DEVELOPMENT APPLICATION SUBMISSION FOR:			
41 & 43 BEACH ROAD,COLLAROY, 2097 LOT 1 DP300846 & LOT 2 SEC 7 DP7391			
DRAWING REGISTER			
DWG NO.	DRAWING	SCALE	REVISION
DA 000	COVER + PHOTOMONTAGES	N/A	C
DA E 100	EXISTING SITE & ROOF PLAN	1:100	A
DA E 110	SITE ANALYSIS PLAN	1:100	A
DA E 120	LOT AMALGAMATION PLAN	1:250	A
DA E 130	DEMOLITION AND WASTE MANAGEMENT PLAN	1:100	A
DA E 140	EXCAVATION & FILL PLAN	1:100	C
DA E 200	EXISTING ELEVATIONS	1:200	A
DA 100	PROPOSED SITE & ROOF PLAN	1:100	A
DA 105	ANALYSIS AGAINST DCP-B1 "WALL HEIGHT CONTROL"	1:100	C
DA 106	ANALYSIS AGAINST DCP-B1 - SE AREA DETAIL	1:100	C
DA 107	ANALYSIS AGAINST DCP-B1 & DCP-B3 - SECTIONS	1:50	C
DA 108	ANALYSIS AGAINST DCP-B1 & DCP-B3 - SECTIONS	1:50	C
DA 110	PROPOSED BASEMENT PLAN	1:100	B
DA 120	PROPOSED GROUND FLOOR PLAN	1:100	B
DA 130	PROPOSED FIRST FLOOR PLAN	1:100	C
DA 150	PROPOSED GFA & FSR CALCULATIONS	1:200	C
DA 160	DESIGN AMENDMENTS - FIRST FLOOR PLAN	1:100	B

DATE	REV	DESCRIPTION
12/12/2019	A	DA ISSUE
03/07/2020	C	DA ISSUE - AMENDMENT C

41 & 43 BEACH ROAD COLLAROY  
LO1 1 DP300846 AND LOT 2 SEC 7 DP7391

COVER + PHOTOMONTAGES

PHOTOMONTAGE - PROPOSED VIEW FROM FISHERMANS BEACH

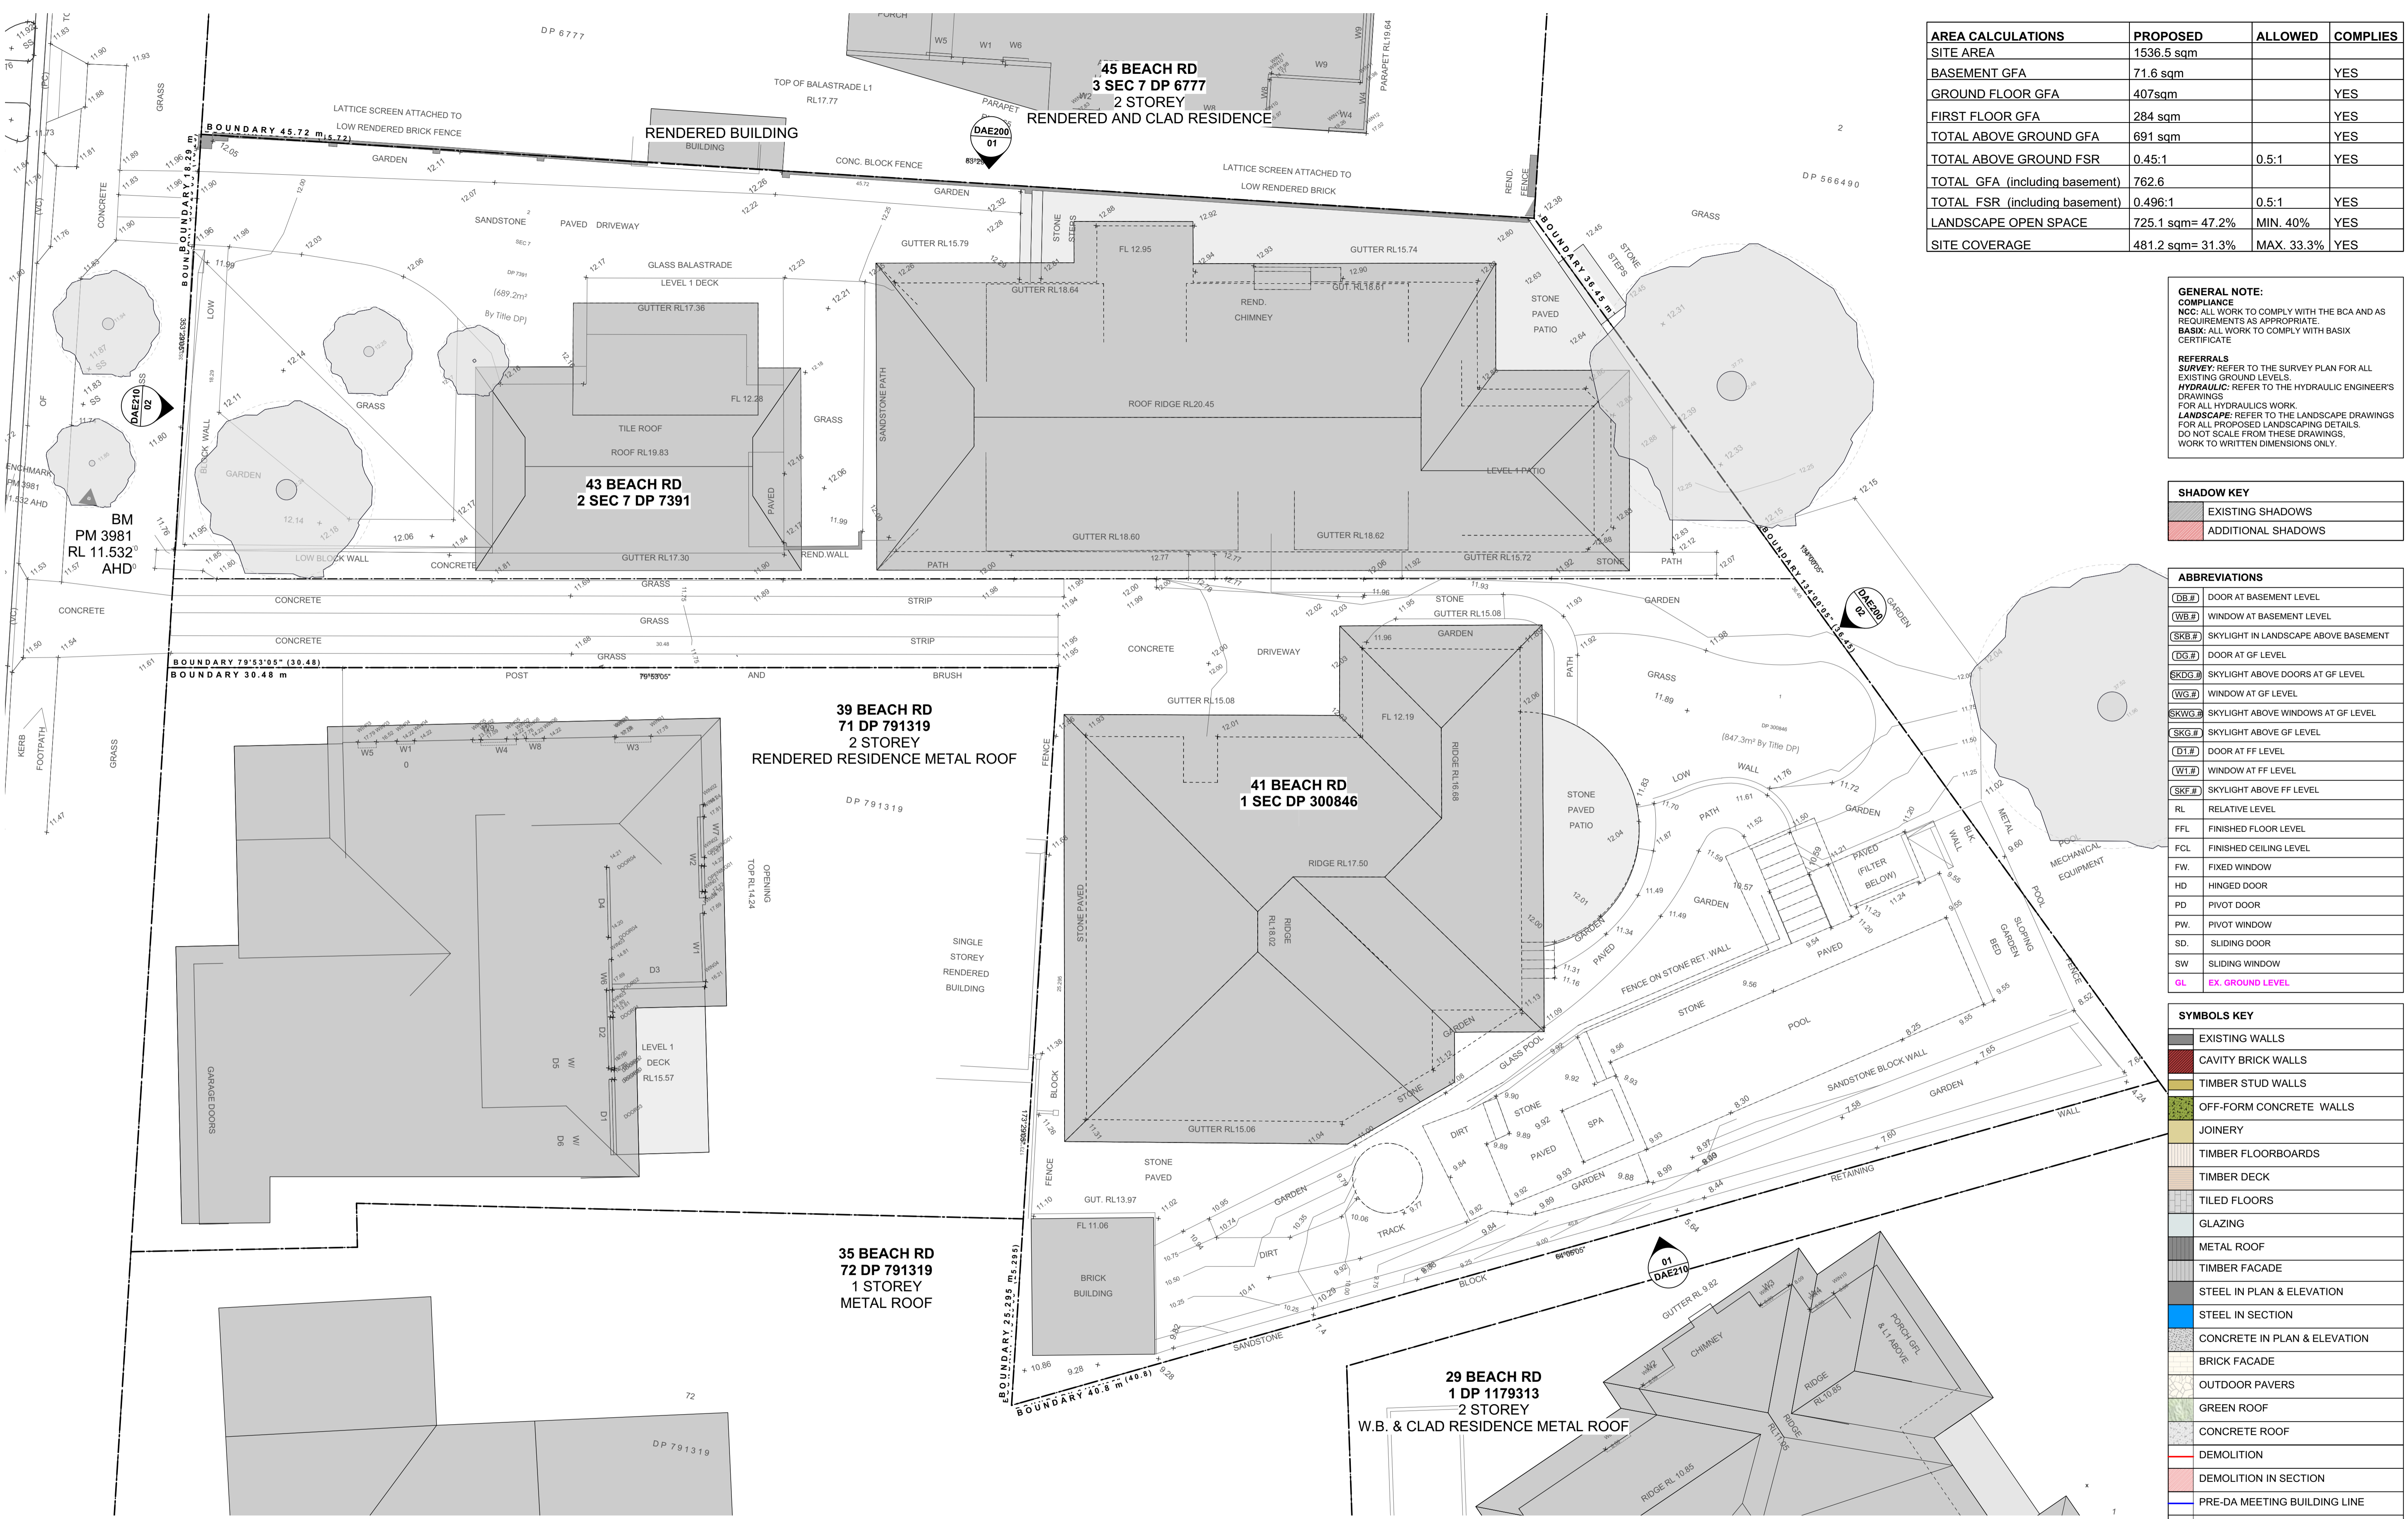
AMENDMENT C CHANGES. SHOWN CLOUDED.

VIEW FROM FISHERMANS BEACH UPDATED WITH NE PROPOSAL.  
DRAWING REGISTER UPDATED.
